CRMC DECISION WORKSHEET

2025-02-014

STATE OF RHODE ISLAND
COASTAL RESOURCES MANAGEMENT COUNCIL
 STAFF REPORT TO THE COUNCIL

Applicant's Name:	John and Aidan MacSweeney
CRMC File Number:	2025-02-14
Project:	Residential development consisting of a 25' x 40' single family dwelling with a driveway, deck and stormwater management system
Location:	Arlington Avenue, Warwick: Plat 356, Lots 162, 163 and 204
Water Type/Name:	Type 2 Low Intensity Use/Narragansett Bay
Coastal Feature:	Erosive coastal bluff and coastal wetland
Plans Reviewed:	"Longmeadow Corner" – CRMC Proposed Residential Development Plan of Land of John W. MacSweeney & Aiden J. MacSweeney, Assessor's Plat 356 Lot 162, Arlington Avenue, Warwick, Rhode Island – 2 Sheets prepared by Angelo M. Raimondi, last revised 03/11/2025

Above: subject lot DEM aerial Nov 2025

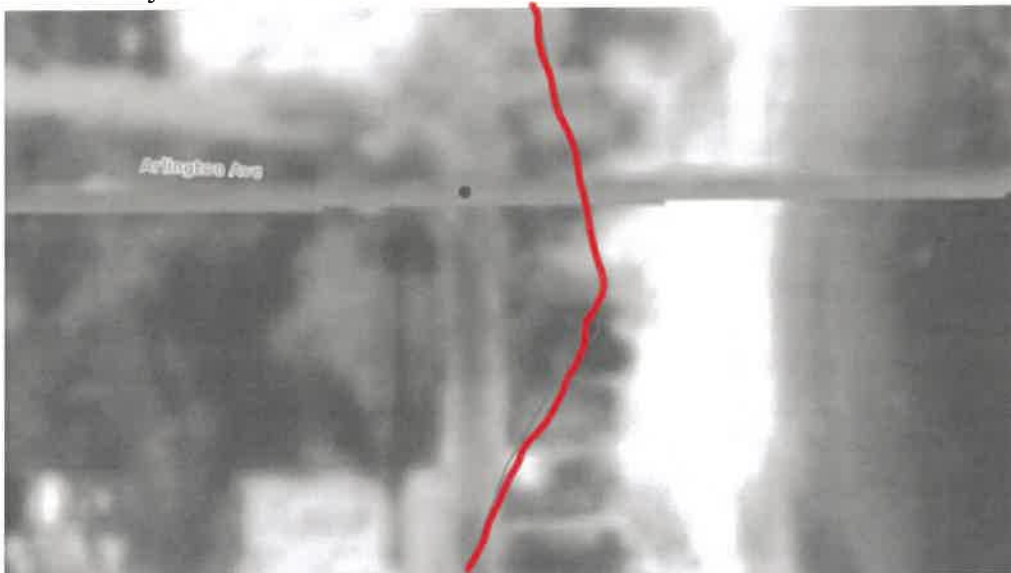
The application asserts that there would be no adverse environmental impacts as a result of construction at the site citing the use of silt fences and the planting of screening vegetation. It is staff's opinion that there would be significant negative impacts from construction at the site. A review of aerial photos and CRMC's shoreline change maps shows significant erosion has already occurred at the site. Construction at the site and the removal of natural vegetation would likely increase erosion at the site and be detrimental to water quality. The proposed rain garden would be located directly adjacent to the coastal feature diminishing its effectiveness for treating runoff and exposing it to potential erosion. There would be no buffer zone adjacent to the onsite coastal wetland.

Although the dwelling would be elevated, much of the lot and surrounding area are subject to frequent flooding. Development of the parcel would expose the site to additional pollutants from the use of fertilizers and pollutants from automobiles. Much of the neighborhood is densely developed and predates CRMC regulations.
